| Model: PN-Fa | Date: 6-Mar-07 | No.: RH320001d |

| Subject: Firmware Release Note: <b><i>System FW</i></b> |  | Prepared by: T. Shintani                  |   |

| Subject : ADF No-feed problem                      |   | Prepared by: T. Shintani |               |

| Subject : The image was waved by ADF scan          |   | Prepared by: T. Shintani |               |

**B2999703**: PAPER INPUT GUIDE

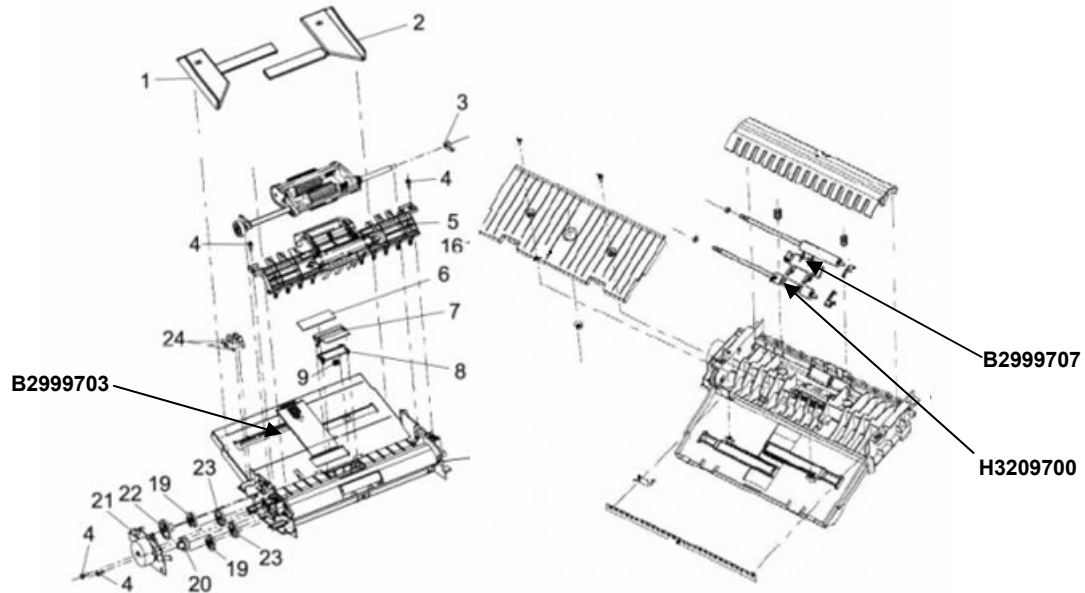
The document cannot be fed when it is loaded in the ADF.

The paper catches on the ribs of the paper input guide.

The shapes of the parts listed below were changed.

If the symptom is reported on a machine produced before the cut-in S/N, replace the paper input guide, paper feed roller foam, and paper deflect guide with the following new parts **together as a set**:

**H3209700**: ANALYSIS ROLLER 2

**B2999707**: PAPER DEFLECT GUIDE

**H3209704**: UPPER COVER

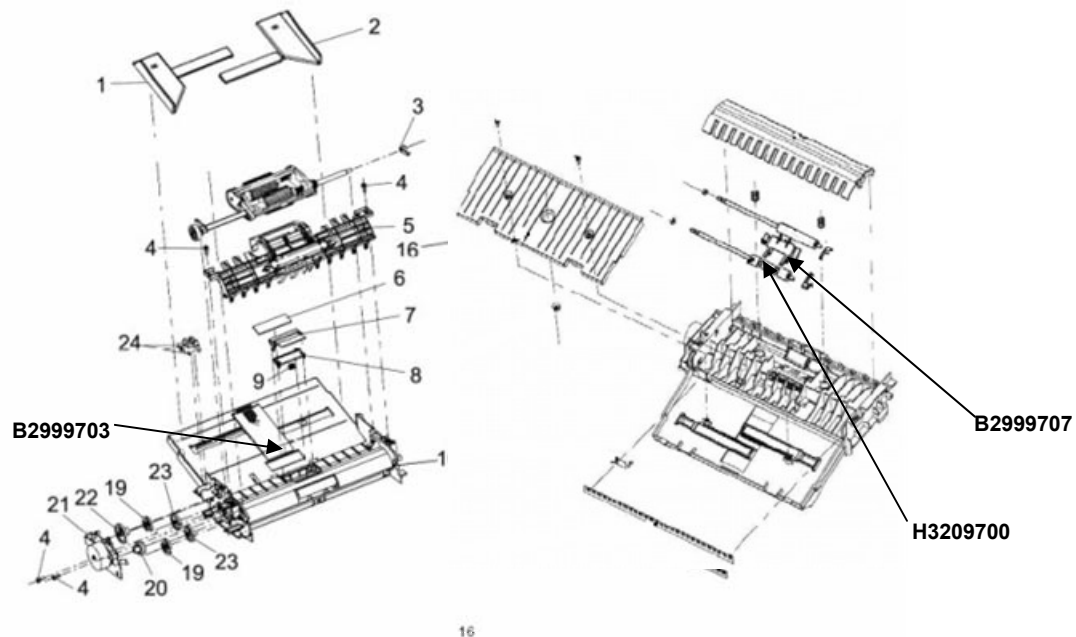
When the document is scanned by the ADF, parts of the image are slightly elongated along the sub-scan direction (at 13mm, 50mm, 230mm from the leading edge).

The document bumps the paper guide and feed rollers during feeding.

The shapes of the parts listed below were changed.

If the symptom is reported on a machine produced before the cut-in S/N, replace the ADF exit tray, paper input guide, foam, and paper deflect guide with the following new parts **together as a set**:

**B2999703**: PAPER INPUT GUIDE

**H3209700**: ANALYSIS ROLLER 2

**B2999707**: PAPER DEFLECT GUIDE

## SYMPTOM

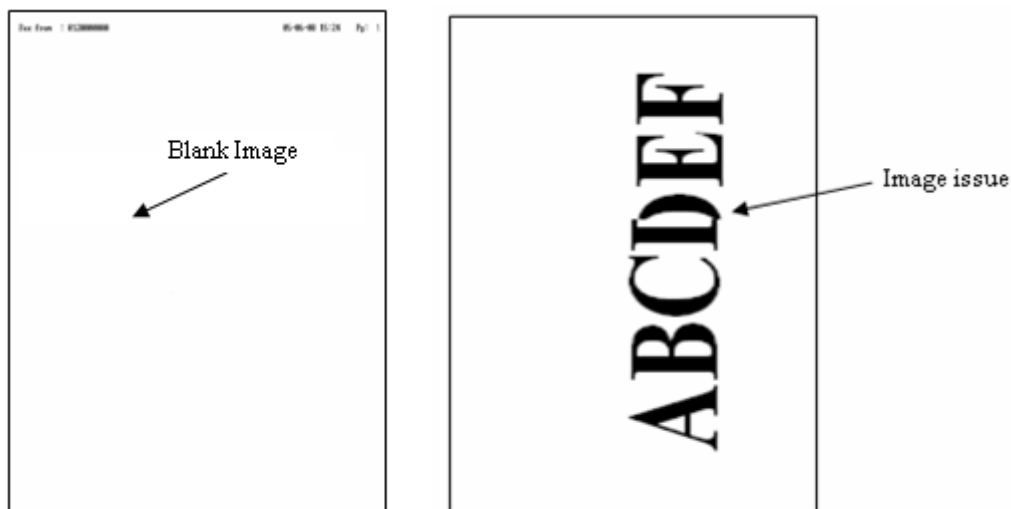
1. An incoming Fax image is blank (but contains the Fax headers)
2. Some parts of incoming Fax Image are shifted or blank.

The Fax line is unstable or electrical noise distorts the Fax line signal.

Try the troubleshooting Procedure on the next page.
